ENGINE - HPC SHAFT - INCREASED LIFE REAR SHAFT - CATEGORY CODE 6 - MOD.ENG-72-0068

V2500-ENG-72-0068

SERVICE BULLETIN

Modification of rear HP compressor shaft assembly
Fig.2 Sheet 1 of 2

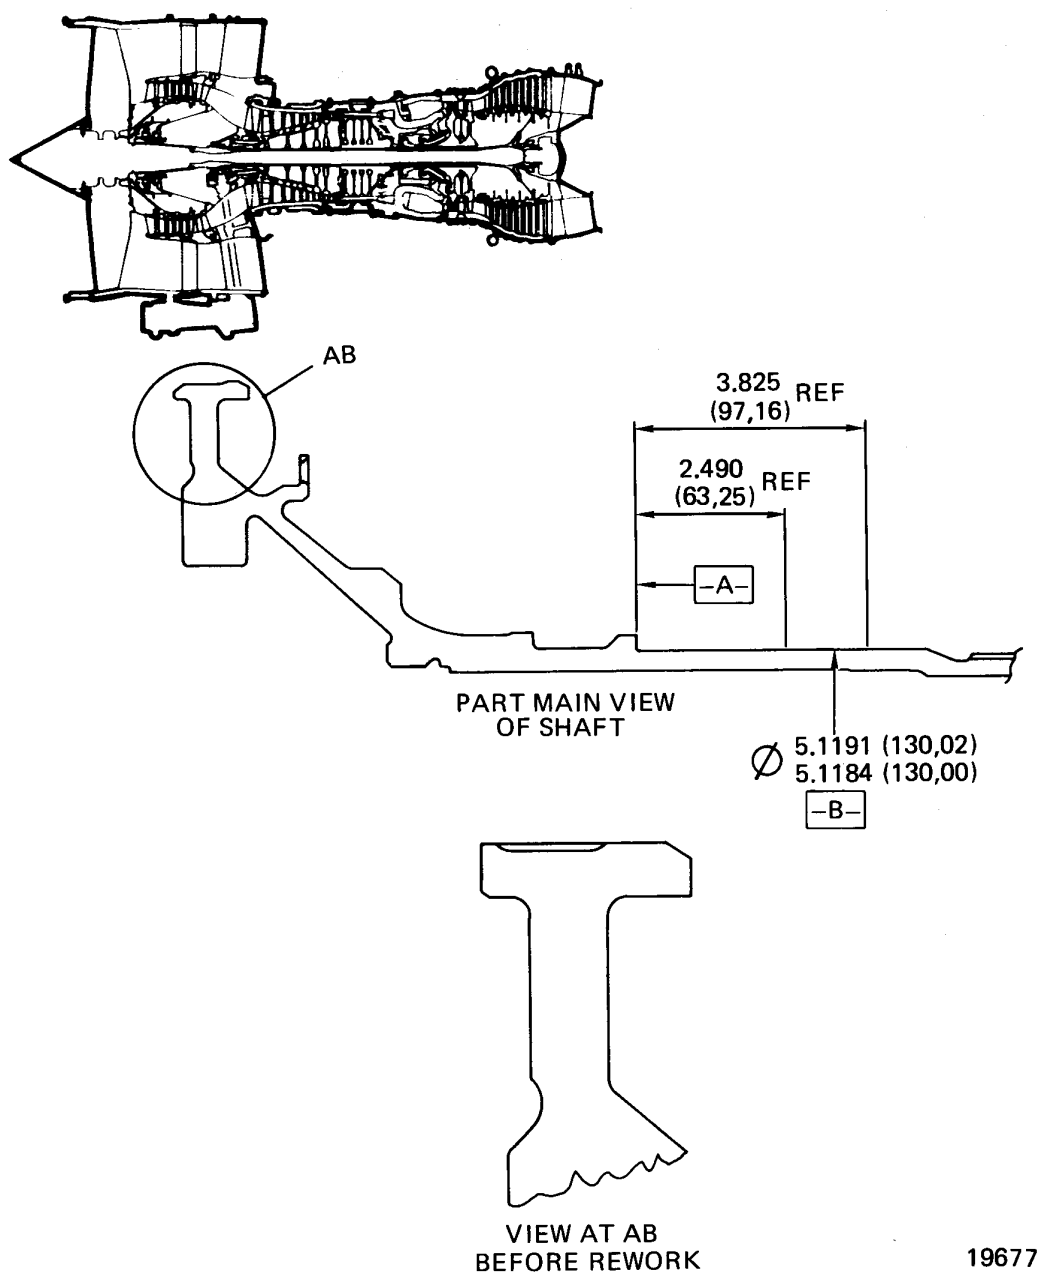
- (1) The axial length of the hammerhead on the mini-disk is reduced from the front face.
- (2) The hard coating on the mini-disk outside diameter is deleted.
- (3) A 40 degree chamfer is added to the front of the mini-disk.
- (4) The outside diameter of the mini-disk is decreased for a part of its length and the remainder has relaxed tolerances.

Procedure	Supplementary Information	
(a) Set-up and machine the outside diameter and the front axial face of the mini-disk at the locations specified	Refer to Figure 2, Sheets 1 and 2, requirements.	
(b) Make a mark adjacent to the old part number to show the new part number. Use the vibro peen method.	Old Part Number 2A1386	New Part Number 2A1990
	Refer to Reference (4), Control No./Task No. 70-09-00-400-501, Marking of Parts.
